General Bid Bulletin No. 11
19 November 2021

METRO MANILA SUBWAY PROJECT PHASE I

PACKAGE CP103:
TWO UNDERGROUND STATIONS (ANONAS AND KATIPUNAN)
AND TUNNELS
(IFB No: 21-035-6)

Metro Manila Subway Project Phase 1 PACKAGE CP103 (Anonas and Katipunan)			
ITEM NO.	REFERENCE/CLAUSE/SECTION	QUERIES	RESPONSE

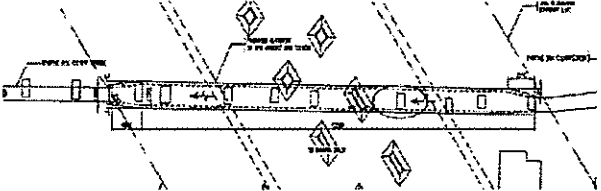
19.	116.4.4 Costs of Employer's and/or	Employer's attendance for Factory acceptance Test.	per diem is included to be provided by the contractor

Metro Manila Subway Project Phase 1 PACKAGE CP103 (Anonas and Katipunan)			
ITEM NO.	REFERENCE/CLAUSE/SECTION	QUERIES	RESPONSE
	Engineer's Attendance at FAT FAT attendance allowance	Please advice, rate of " pocket (per-diem) allowance per day for a person	
<i>Volume II Works Requirements Section VI Works Requirements – Technical Specification (TS)</i>

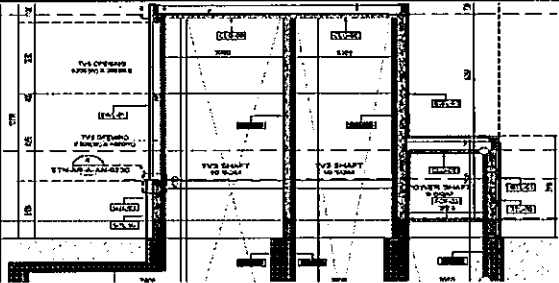
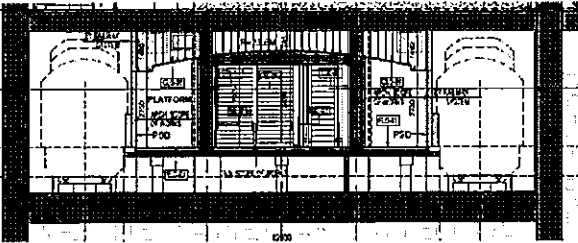
23.	Page 183/ TS 2100.14.1 Method of Measurement 2) Tunnel Work b) Production and Installation of Tunnel Segment Method of Measurement 2) Tunnel Work b) Production and Installation of	<p>Same as the payment of TBM, to reduce the overburden of negative cashflow of the Contractor, the Bidder proposes the payment schedule to be defined as drafted as below. Please confirm your acceptance.</p> <p>"Payment for Pay Item 2100 (4) shall be made in the following manner:</p> <p>(i) 80% of the unit price for Pay Item No. 2100(4)</p>	Payment terms for Pay Item 2100 (4) shall be kept.

Metro Manila Subway Project Phase 1 PACKAGE CP103 (Anonas and Katipunan)			
ITEM NO.	REFERENCE/CLAUSE/SECTION	QUERIES	RESPONSE
	Tunnel Segment Payment shall be made in the interim payment application submitted by the Contractor pursuant to GCC Sub-Clause 14.3 and certified by the Engineer under GCC Sub-Clause 14.6. Payment shall be made in the interim payment application submitted by the Contractor pursuant to GCC Sub-Clause 14.3 and certified by the Engineer under GCC Sub-Clause 14.6.	shall be paid in the interim payment application submitted by the Contractor pursuant to GCC Sub-Clause 14.3 and certified by the Engineer under GCC Sub-Clause 14.6 upon completion of segment production at a segment factory; and (i) 10% of the unit price for Pay Item No. 2100(4) shall be paid in the interim payment application submitted by the Contractor pursuant to GCC Sub-Clause 14.3 and certified by the Engineer under GCC Sub-Clause 14.6 upon completion of segment delivery at Site; and (iii) Balance 10% of the Lump Sum price shall be paid in the interim payment application submitted by the Contractor pursuant to GCC Sub-Clause 14.3 and certified by the Engineer under GCC Sub-Clause 14.6 upon completion of installation of segment."
